## Errata Document

A. This document details the limitations of the cascading option of the AD73360 due to a bug in the current silicon.

Figure 2. Cascade Timing for a Three-Device Cascade

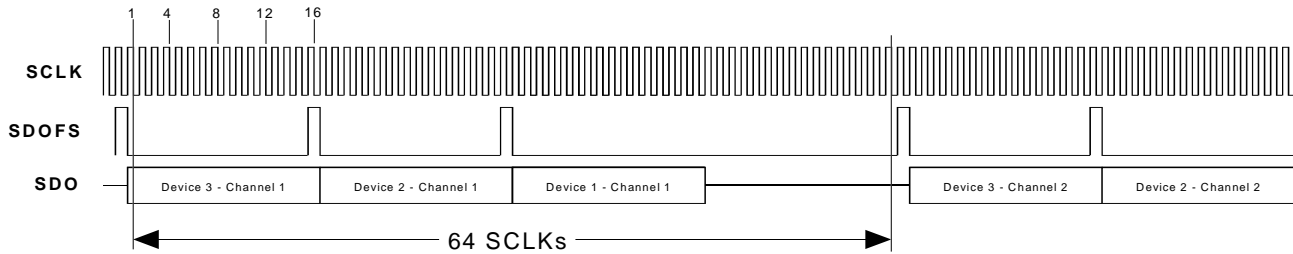
For cascades of more than two devices the AD73360 will leave too many SCLKs between transmitting channel information. This increases the time it takes to transmit the ADC data and since a DSP or microcontroller must read data from all the ADCs in the cascade in one sample period the number of devices which can be cascaded will be limited. Figure 2 shows the effect the additional SCLKs have on a cascade of three devices.

For a cascade of a given length, the SCLK rate and Sample Period will determine if the cascade can be used successfully. A low sample rate will allow more time for the ADC data to be read. Similarly a high SCLK rate will transmit the data in a shorter time. Since both the SCLK rate and Sample Rate are derived from the same DMCLK the number of combinations is limited. As most applications will require a predetermined sample rate, the SCLK speed will be the limiting factor in the cascade length that can be used. Table I shows the maximum cascade length for a given SCLK and Sample Rate. The table assumes that a MCLK of 16.384MHz is used.
